Version 1.0 – December 21, 2020

**Las Vegas Metroplex Project
Written Re-Evaluation and Record of Decision for
Changes to the Final EA Designs**

**HOOVER SEVEN SID
RNAV (RNP) Z RWY 19R
RNAV (GPS) Y RWY 19R
RNAV (RNP) Z RWY 19L
GAMES STAR**

Figure 1: HOOVER SEVEN SID Final EA Design

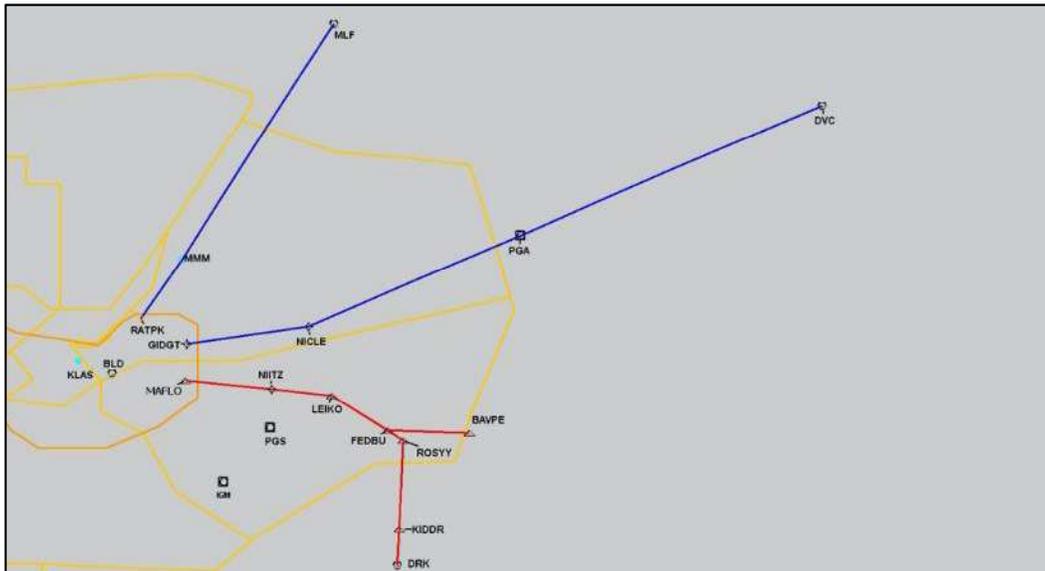
During review by FAA Flight Inspection Services, two transitions to the south and east (DRK and BAVPE) of the Final EA Design for the KLAS HOOVER SEVEN SID, a conventional procedure (i.e., defined by ground-based navigational aids), failed flight inspection requirements due to radio reception limitations of the Flagstaff (FLG) Very High Frequency Omni-Directional Range (VOR). The lack of radio reception may be due to distance, terrain, or other factors. The LAS Metroplex Design and Implementation (D&I) Team was advised of this failure on July 23, 2020. Conversely, Flight Inspection found the two transitions to the northeast and east (MLF and DVC) in compliance. The Final EA Design for the KLAS HOOVER SEVEN SID is shown in Figure 1 below. The two transitions that failed flight inspection are depicted in red and the two transitions that passed flight inspection to the east and northeast are shown in blue.

Figure 2: HOOVER SEVEN SID Changed Design of BAVPE and DRK Transitions

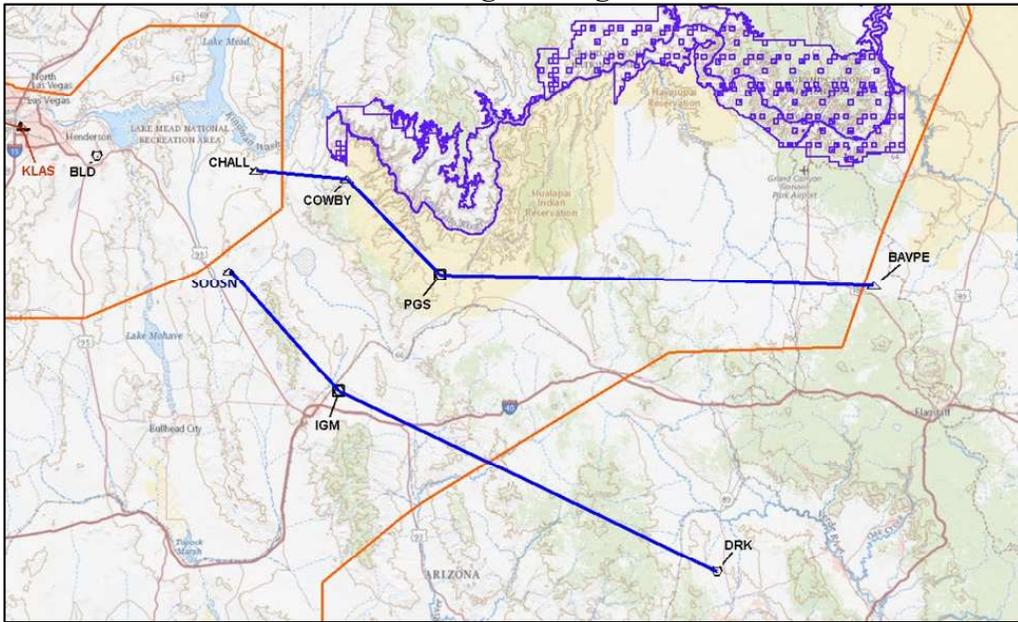
Transitions to the south and east are critical to provide segregated routes for KLAS departure aircraft that do not have RNAV capabilities. The D&I Team developed changes to the design of the transitions to the south and east, utilizing available navigational aids information. The Changed Design would still route aircraft to BAVPE waypoint and Drake (DRK) Very High Frequency Omni-Directional Range Collocated Tactical Air Navigation System (VORTAC), but would utilize the Boulder (BLD) VORTAC, Kingman (IGM) VOR, and Peach Springs (PGS) VORTAC. The Design Changes to the BAVPE and DRK transitions for the HOOVER SEVEN SID are shown in Figure 2 in blue. The pixelated purple area in Figures 2 through 5 below depicts the Grand Canyon National Park derived from data provided by the National Park Service. The Changed Design is still subject to flight inspection, which is planned for January 2021. The Final EA Design and the Changed Design are depicted in Figure 3.

Figure 4: HOOVER SEVEN SID Changed Design of BAVPE and DRK Transitions (blue) and Final EA Design for the RASLR RNAV SID (red)

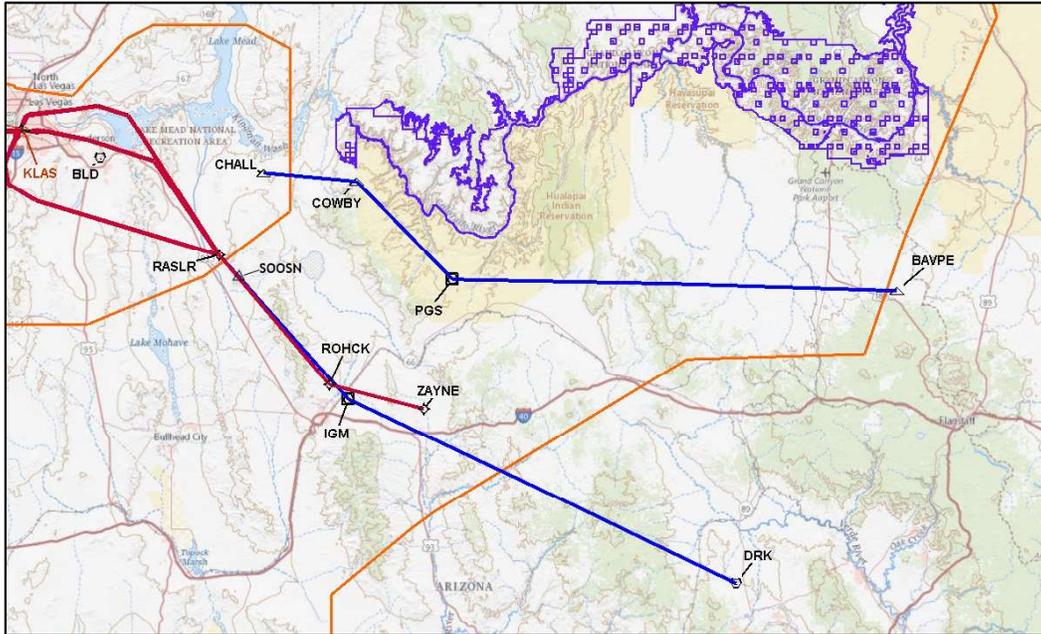
The Changed Design of the HOOVER SEVEN SID DRK transition would route aircraft along a lateral path similar to the proposed RASLR RNAV SID in the Final EA Design, beginning with waypoint SOOSN, which would intercept the IGM VOR, and then along a leg from IGM to the DRK VOR, as depicted in Figure 4. The Changed Design of the HOOVER SEVEN SID BAVPE transition would utilize the existing HOOVER SIX SID PGS transition, and adds a leg from PGS to BAVPE. The PGS to BAVPE portion overlies existing segments of jet routes J72 and J86, as depicted in Figure 5.

Figure 6: RNAV (RNP) Z RWY 19R Approach Final EA Design (red) Compared to the Changed Design (blue)

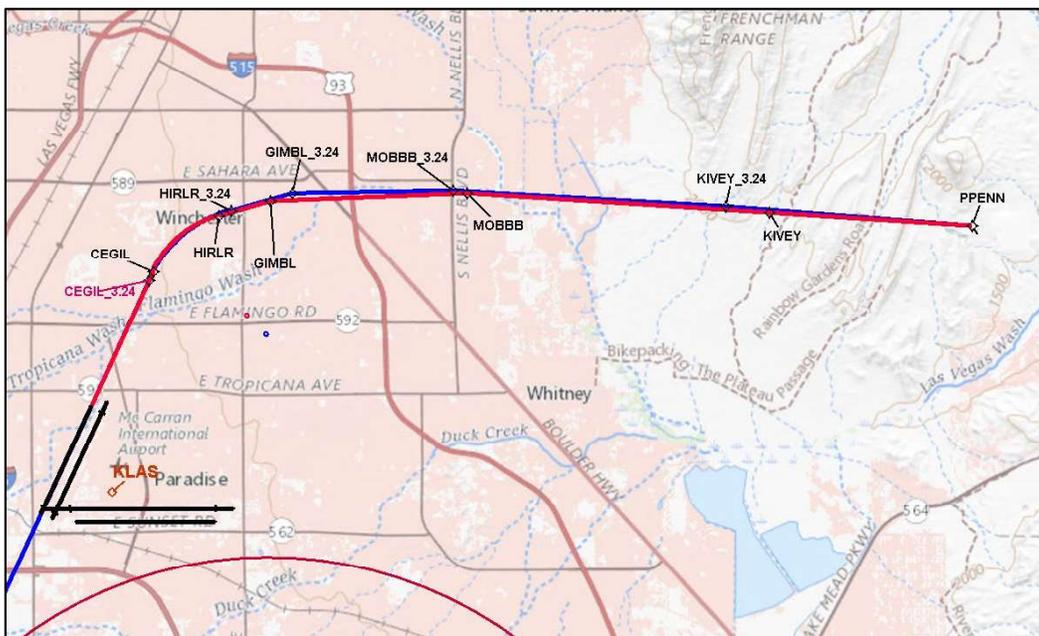
Following approval of the FONSI/ROD, changes to the Final EA Design for the RNAV (RNP) Z RWY 19R approach procedure were developed to better align the procedure with safety criteria, primarily related to adjustments in the final approach and glide path angle (GPA). Figure 6 presents the Final EA Design for the RNAV (RNP) Z RWY 19R approach procedure and the Changed Design.

The changes to the RNAV (RNP) Z RWY 19R approach procedure at KLAS are necessary for safety reasons. Specifically, the Final EA Design had a 3.5-degree GPA. The airlines requested that the D&I Team lower the GPA because of erroneous altitude readouts during high ambient

air temperatures (hot weather). During those conditions, the instruments show the aircraft on the glide path; however, the aircraft will actually be above the GPA. The steep descent prevents the aircraft from slowing to a safe landing speed. This can make it difficult for aircraft to slow to a safe landing speed, which can result in an unstable approach and require the flight crew to execute a missed approach/go-around.

The FAA has made changes to the Final EA Design for the RNAV (RNP) Z RWY 19R approach procedure to change the GPA to 3.24 degrees to mitigate the safety concerns raised by the airlines. Changing the GPA for the RNAV (RNP) Z RWY 19R procedure also required changing the GPA for the RNAV (GPS) Y RWY 19R procedure, so the Visual Glide Slope Indicator (VGSI) would be able to assist pilots flying either approach. The changes to the Final EA Design of the RNAV (GPS) Y RWY 19R approach procedure are described separately in Section 2.3.

Figure 7: RNAV (RNP) Z RWY 19R Approach Final EA Design (red) and the Changed Design (blue)

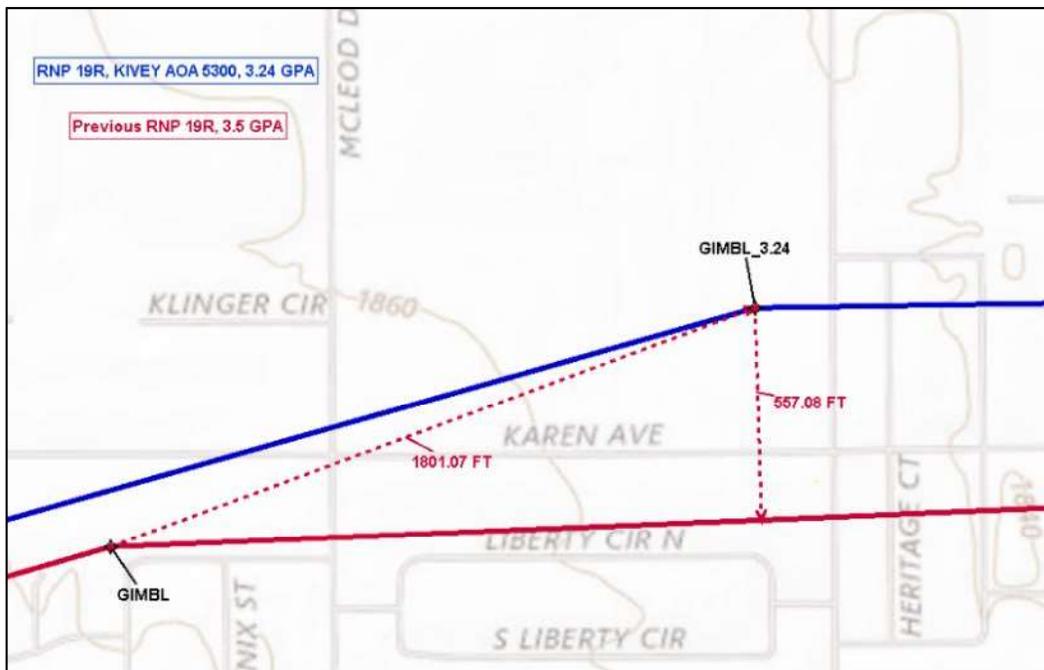
At the point of the largest lateral change (at the changed GIMBL waypoint), the changed procedure would route aircraft approximately 557 feet north of the Final EA Design. As previously stated, the FAA does not anticipate an increase in the volume of air traffic flying the changed procedure compared to the Final EA Design. In addition, the FAA does not anticipate that the Changed Design would change runway usage compared to the Final EA Design. The area of lateral change is presented in Figure 7.

The FAA compared the Design Change utilizing a 3.24 degree GPA with the Final EA Design utilizing a 3.5 degree GPA, and determined that the Design Change would result in a lateral shift of approximately 557 feet in the segment near GIMBL waypoint. Other waypoints would also shift slightly but with no discernable change in track from the Final EA Design. The anticipated

altitude at the changed GIMBL waypoint on the final approach for the Changed Design of the RNAV (RNP) Z RWY 19R procedure would be at or above 3,500 ft MSL (approximately 1,679 ft AGL).

Figure 8: RNAV (GPS) Y RWY 19R Final EA Design (red) and the Changed Design (green)

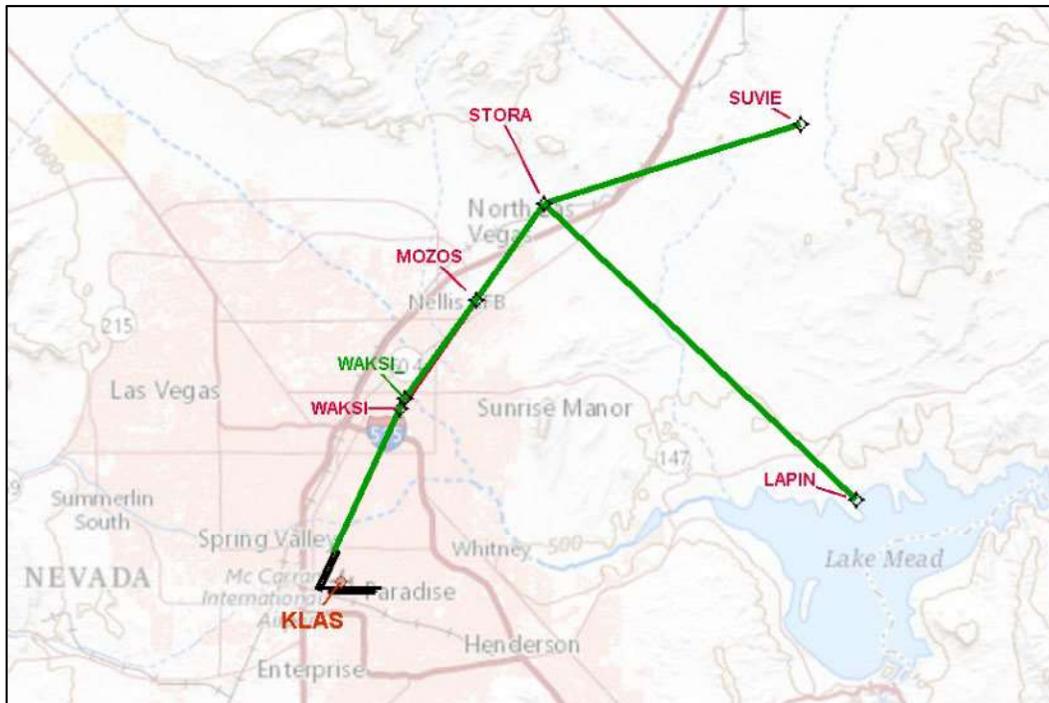
Following approval of the FONSI/ROD, changes to the Final EA Design for the RNAV (GPS) Y RWY 19R approach procedure were developed to better align the procedures with safety criteria, primarily related to adjustments in the final approach and GPA. The changes to RNAV (GPS) Y RWY 19R are related to the changes to RNAV (RNP) Z RWY 19R as described earlier in Section 2.2. Figure 8 compares the Final EA Design for RNAV (GPS) Y RWY 19R to the Changed Design. The only lateral shift in the procedure path is to the location of WAKSI waypoint.

The changes to Final EA Design of the RNAV (GPS) Y RWY 19R approach procedure at KLAS are necessary for safety reasons. Specifically, the D&I Team designed the RNAV (RNP) Z RWY 19R and RNAV (GPS) Y RWY 19R approach procedures with a 3.5-degree GPA. The airlines

requested that the D&I Team lower the GPA because of erroneous altitude readouts during high ambient air temperatures (hot weather). During those conditions, the instruments show the aircraft on the glide path; however, the aircraft will actually be above the GPA. The steep descent prevents the aircraft from slowing to a safe landing speed. This can make it difficult for aircraft to slow to a safe landing speed, which can result in an unstable approach and require the flight crew to execute a missed approach/go-around.

As described above, the FAA has made changes to the Final EA Design for the RNAV (RNP) Z RWY 19R procedure to change the GPA to 3.24 degrees to mitigate the safety concerns raised by airlines. That change also requires the GPA for the RNAV (GPS) Y RWY 19R approach procedure to change in order for the VGSI to be able to assist pilots flying either approach. At the point of the largest lateral change (at WAKSI waypoint), the Changed Design of the RNAV (GPS) Y RWY 19R approach procedure would route aircraft approximately 500 ft northwest of the Final EA Design. As previously stated, the FAA does not anticipate an increase in the volume of air traffic flying the Changed Design when compared to the Final EA Design. In addition, the Changed Design would not be likely to change runway usage. The area of lateral change is presented in Figure 9, and a zoomed in view is presented in Figure 10.

Figure 11: RNAV (RNP) Z RWY 19L Final EA Design (black) and the Changed Design (green)

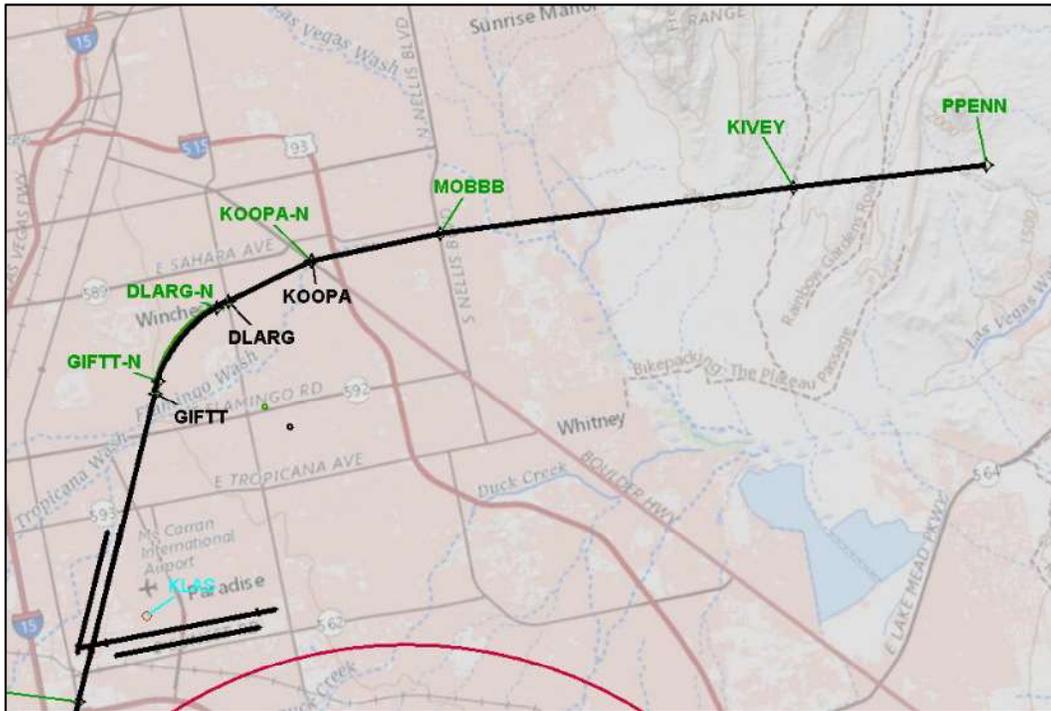
The changes to the Final EA Design for the RNAV (RNP) Z RWY 19L approach procedure are necessary for the procedure to conform to FAA safety criteria. On September 16, 2020, during an FAA evaluation and after the FONSI/ROD, the Final EA Design for RNAV (RNP) Z RWY 19L was determined to have insufficient spacing between the final rollout point and the decision altitude (DA) along the final approach. Therefore, to correct the proposed procedure and conform to approach criteria, the Design Changes would shift GIFTT waypoint north along the Final EA Design track, which would necessitate another shift in the next waypoint (DLARG waypoint) to the southwest along the Final EA Design track. The Changed Design results in a slightly longer final approach, which increases safety by giving pilots more distance before they reach the altitude at which they must determine whether they are safely lined up and configured to land. Figure 11 compares the Final EA Design for RNAV (RNP) Z RWY 19L to the Changed Design. The changes to the locations of the GIFTT and DLARG waypoints would result in a lateral shift of the procedure arc between the two waypoints as depicted in Figure 11. Figure 12 presents a zoomed in view of the area of lateral route change.

There would be no discernable change in altitude, and the maximum lateral shift in track would be approximately 212 ft northwest from the Final EA Design. As previously stated, the FAA

- GIFTT – at or above 2,748 ft MSL (~809 ft AGL)
- DLARG – at or above 3,107 ft MSL (~1,240 ft AGL)
- Altitude at greatest change in lateral distance of 212 ft – at or above 2,928 ft MSL (~1,009 ft AGL)
